ADDENDUM NO. TEN (10)

Project: Harold D. Thompson Regional Water Reclamation Facility
Phase 1 – 2.5 MGD

Date of Addendum: June 5, 2012

Owner: Lower Fountain Metropolitan Sewage Disposal District

LINES 'GG', 'HH' AND 'II' - PLAN AND PROFILE
 HAROLD D. THOMPSON REGIONAL WATER RECLAMATION FACILITY
 LOWER FOUNTAIN METROPOLITAN SEWAGE DISPOSAL DISTRICT

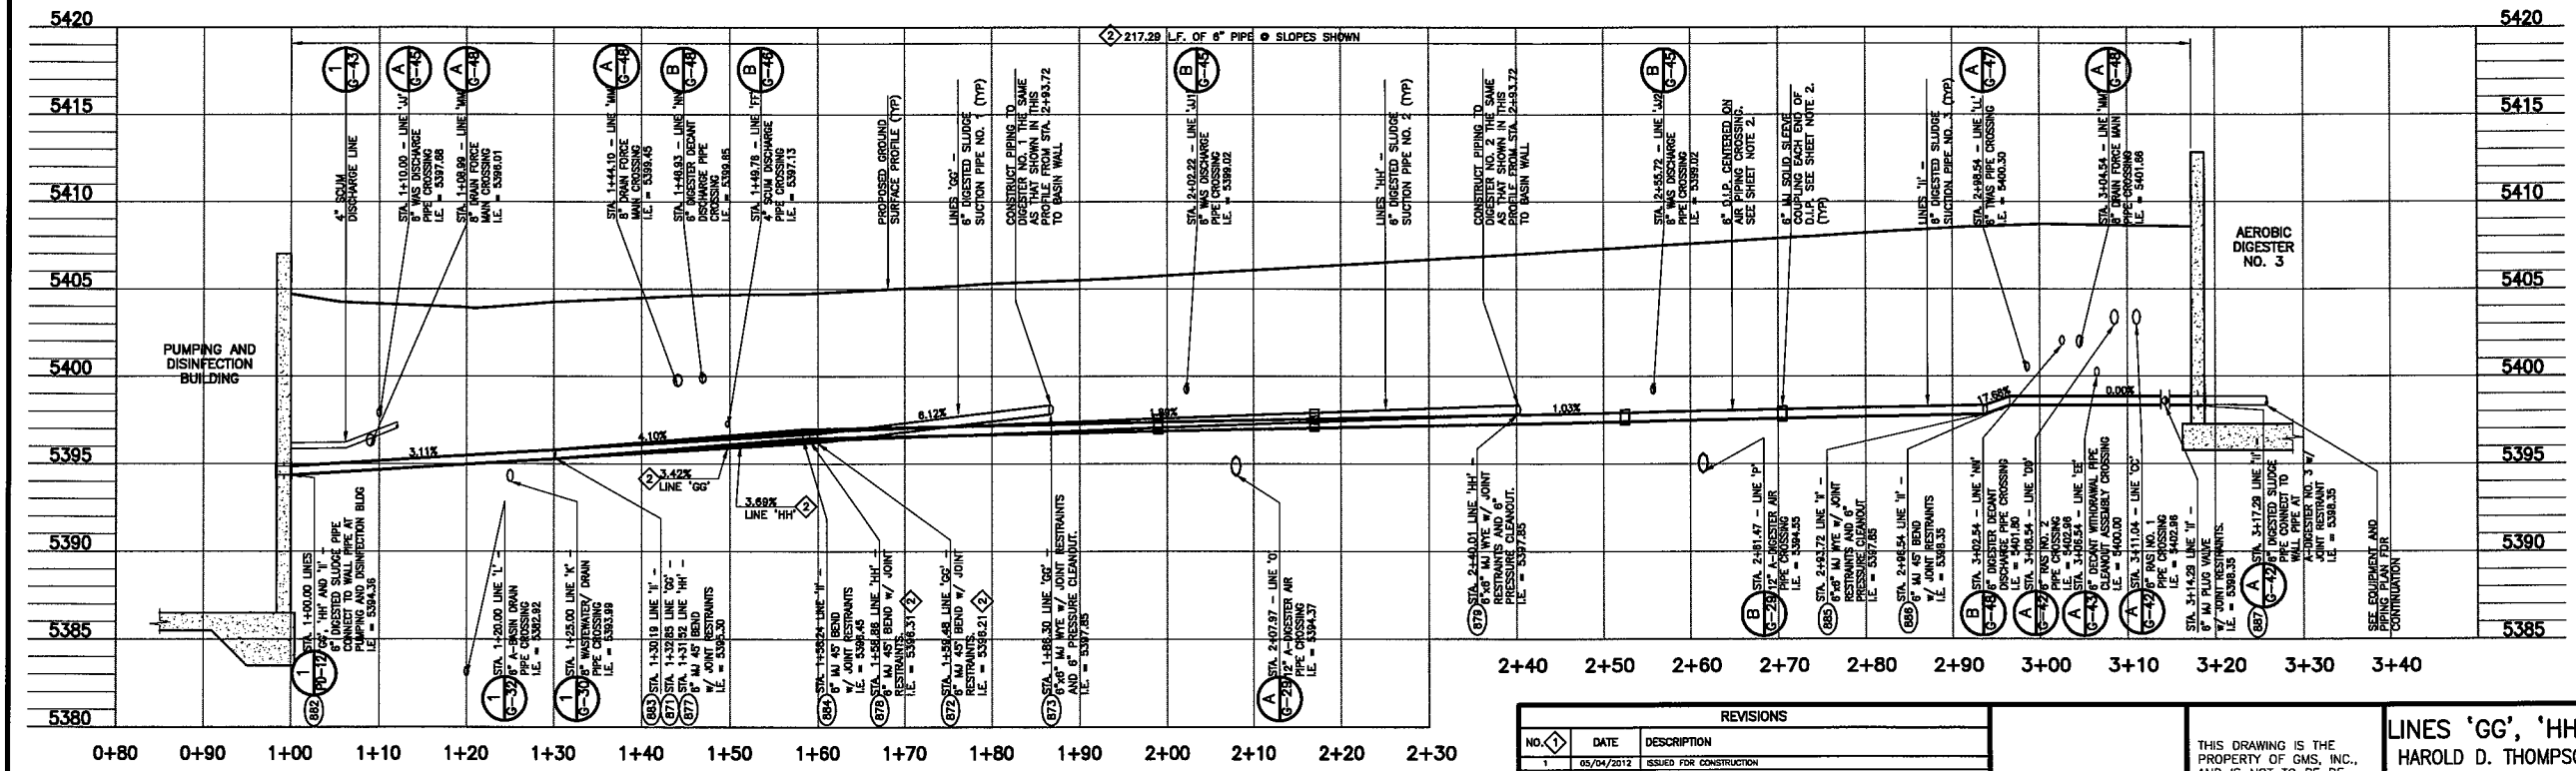
A. **REVISED** and **REISSUED – Revision Date of 05/30/2012**: This Sheet G-44 shall replace the Drawing issued on 05/24/2012.

The attached Sheet G-44 reflects revisions to invert elevation and adjacent pipe slope for 45° bends at Sta. 1+58.86 and Sta. 1+59.48 and the revised pipe material specification.

| REVISIONS | | |
|-----------|------------|---|
| 2 | 05/30/2012 | REVISE HIGHEST ELEVATION AND ADJACENT PIPE SLOPE FOR 45° BENDS AT STA. 1+58.88 AND 1+59.48 AND REVISE PIPE MATERIAL SPECIFICATION PER ADDENDUM NO. 10 |
